# Groundwater Application Review Summary Form

Application # G- 19064 RR #2

TO: Water Rights Section Date 4/17/2023  
 FROM: Groundwater Section Travis Brown  
Reviewer's Name  
 SUBJECT: Application G- 19064 – REREVIEW #2 Supersedes review of 3/22/2022  
Date of Review(s)

Water-Level Measurements in Nearby Wells (Hydrograph)

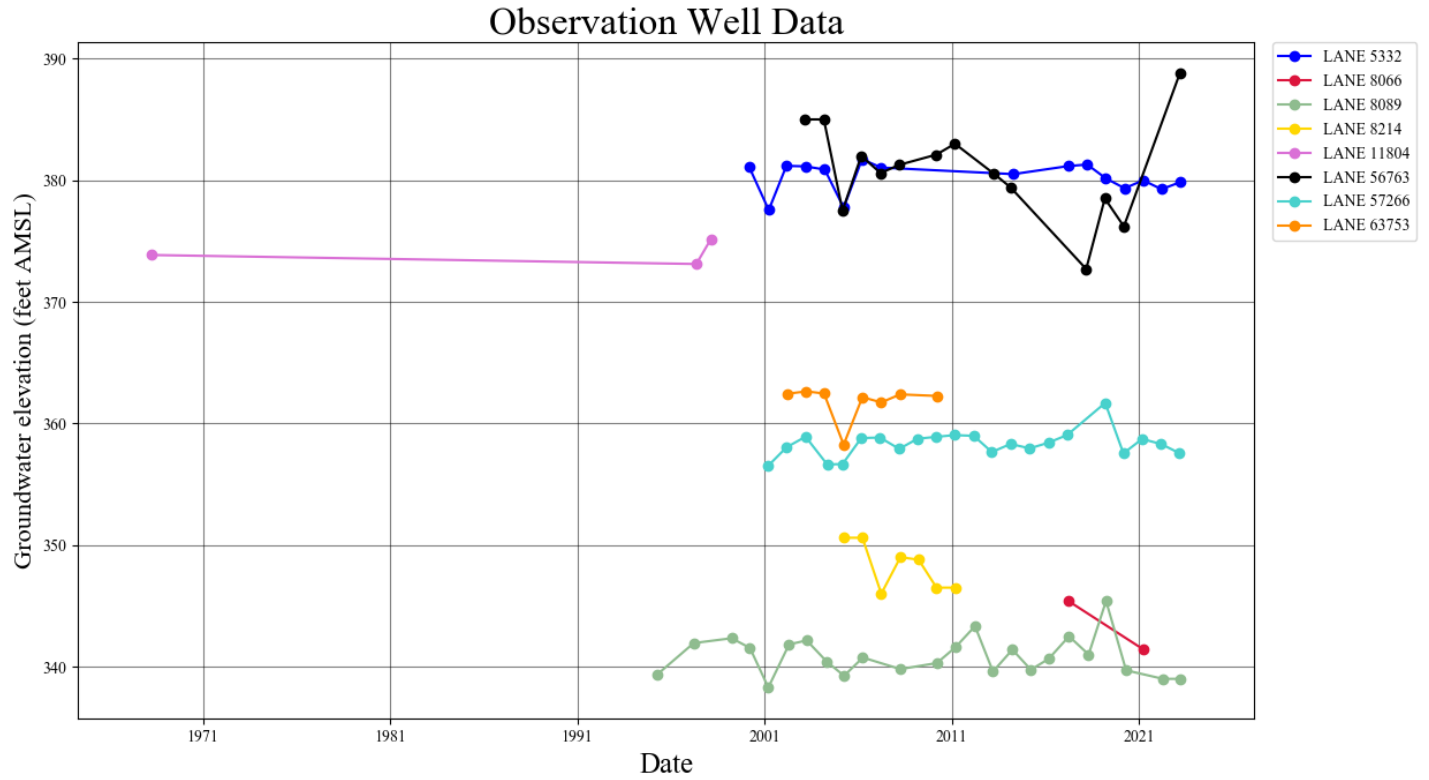
B3. **Groundwater availability remarks:** Area water levels indicate the groundwater is not over-appropriated (see attached Hydrograph).
